RICHMOND COMMUNITY SCHOOL
Richmond High School: Mechanical Modernization Project
LWC Commission No. 20104.02

ADDENDUM #03
October 3, 2021

ROBERT A. HANKS
REGISTERED PROFESSIONAL ENGINEER
No. 10707744
STATE OF INDIANA
Checked: JAE
Date: 2010.04.02
Drawing No.: NGM
Project No.: E002
© 2021 LWC, INCORPORATED

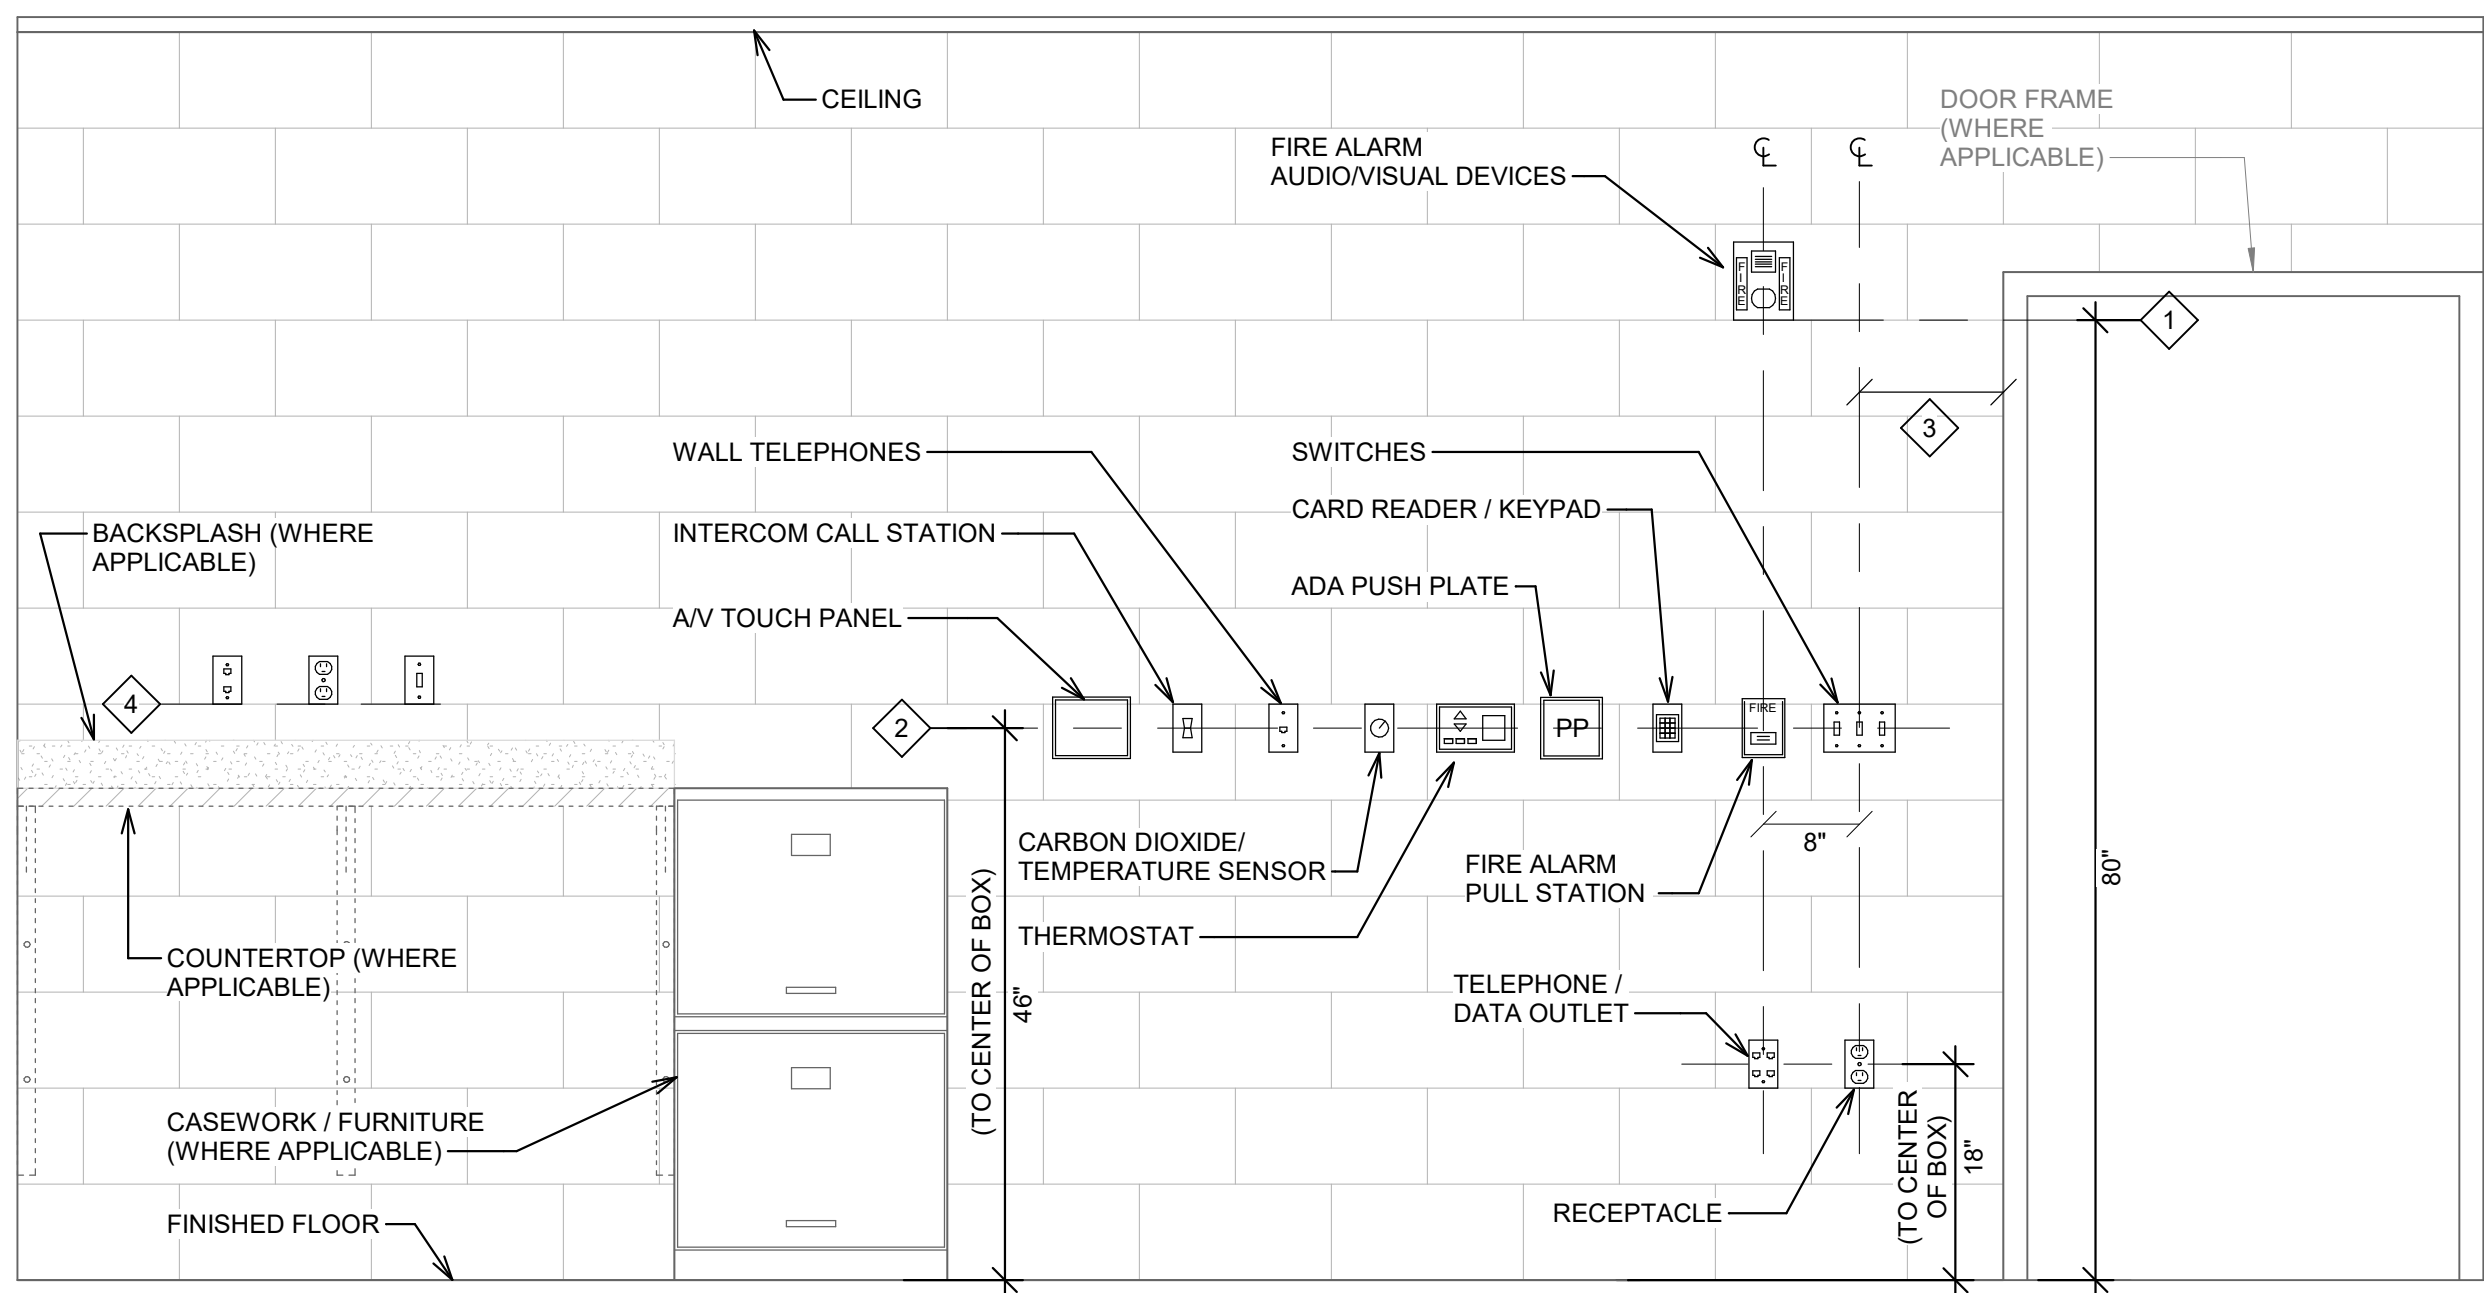
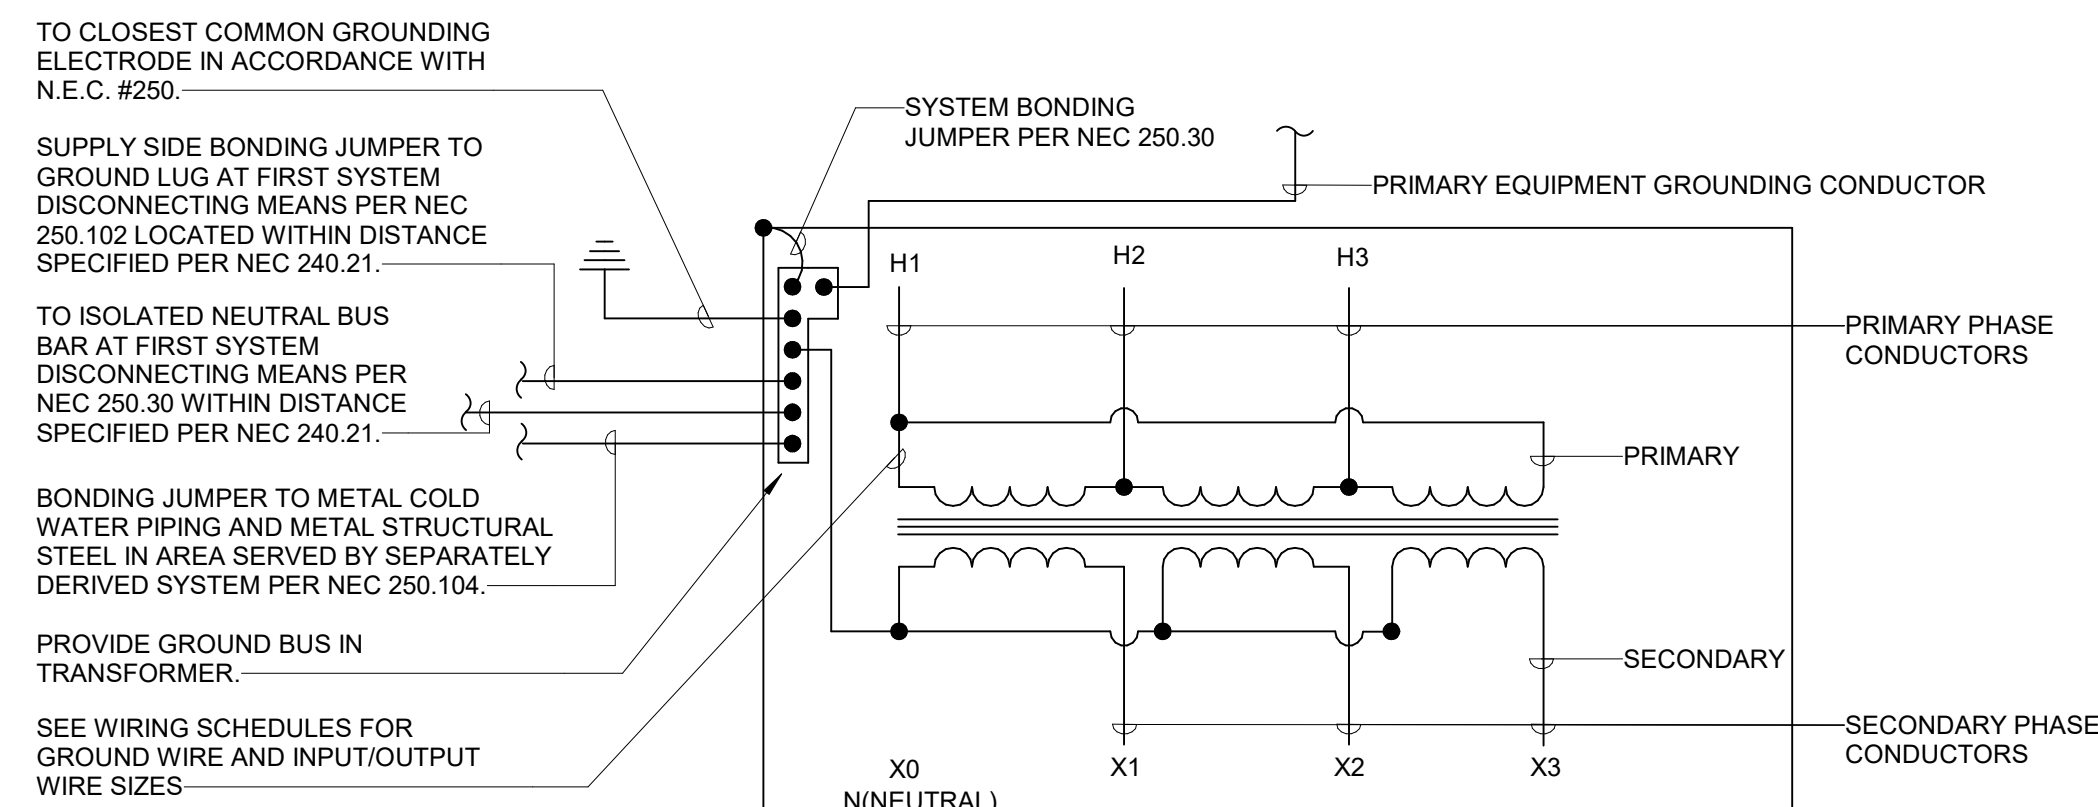
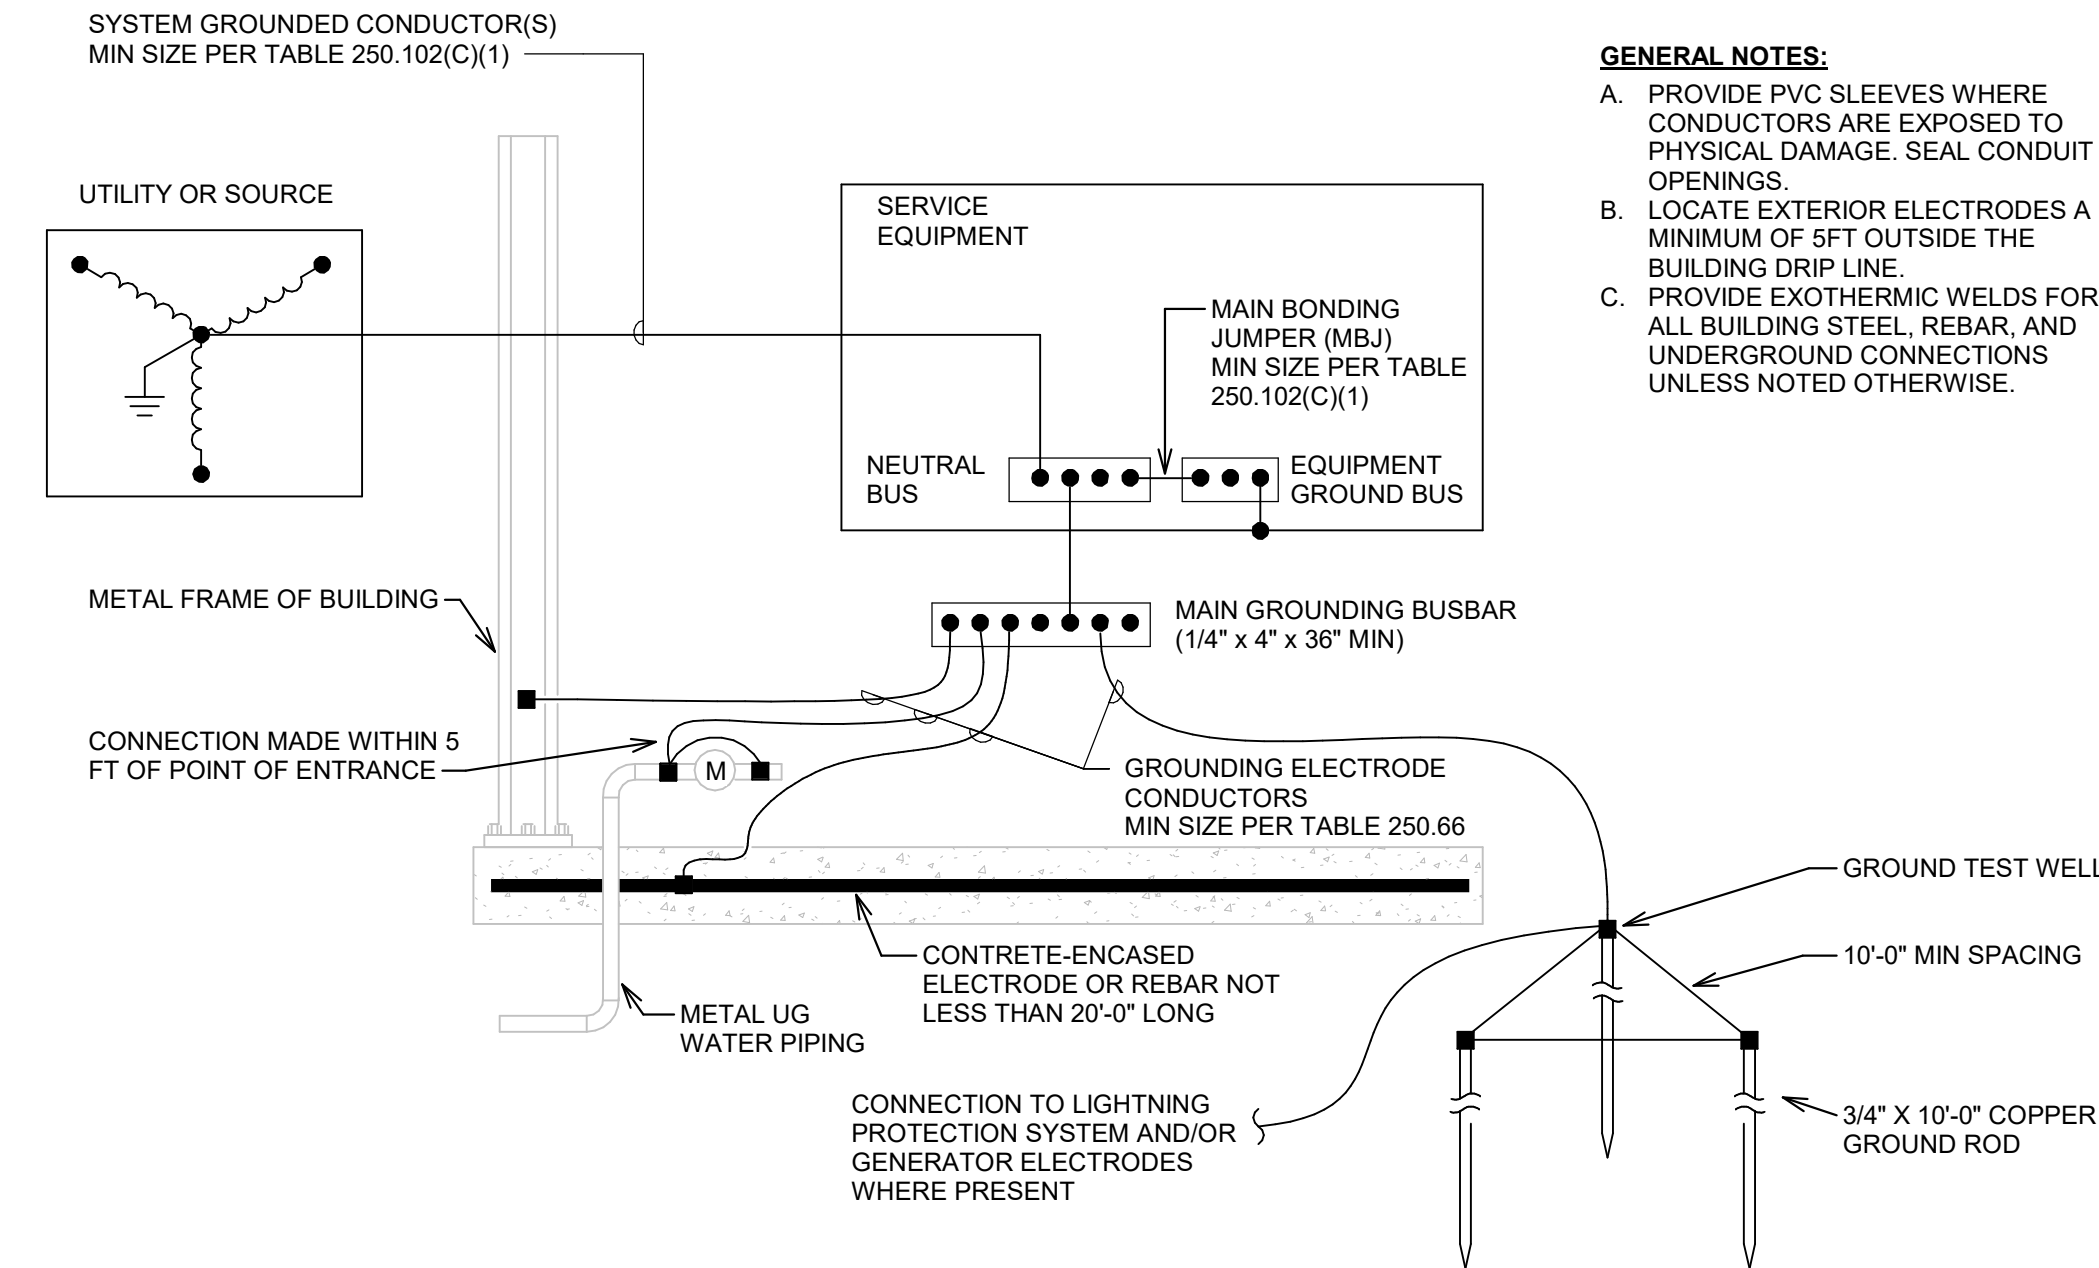
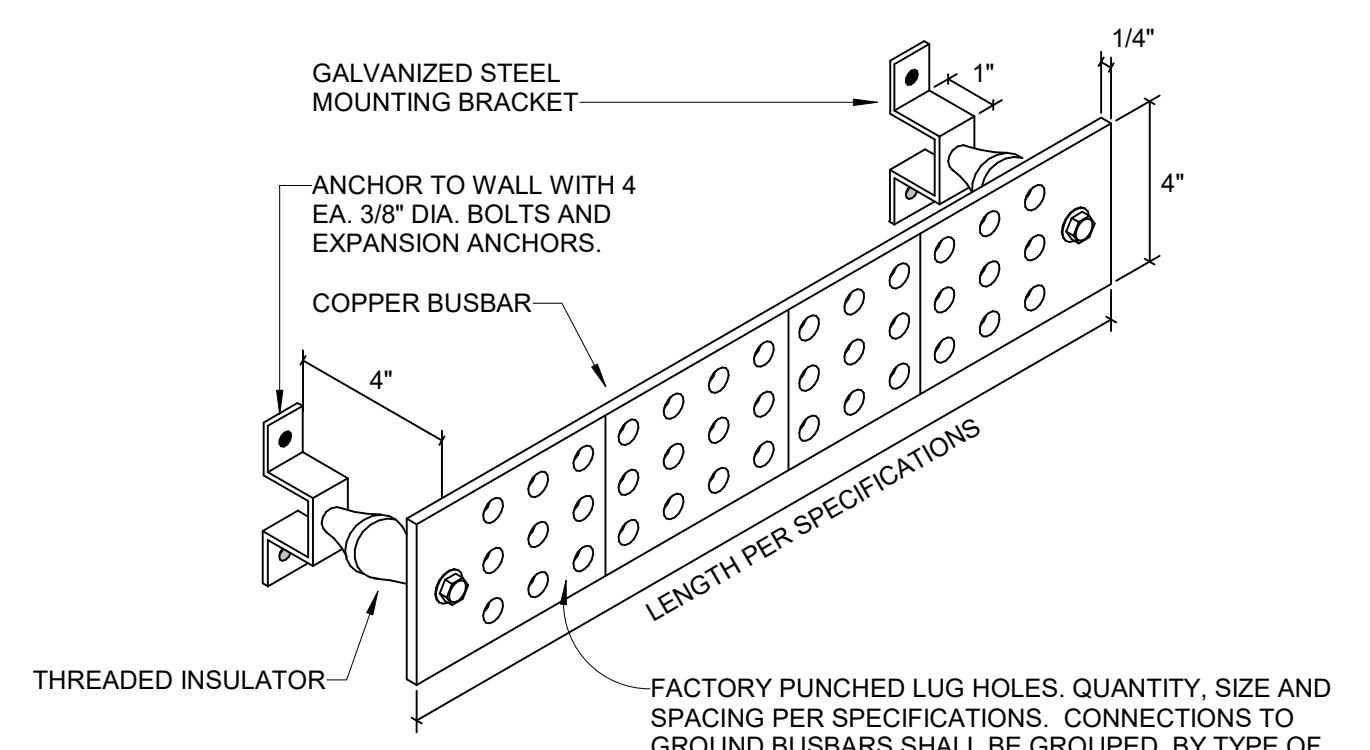
ITEM NO.7 Drawing E002

- A. Added fixture type T3 to fixture schedule.
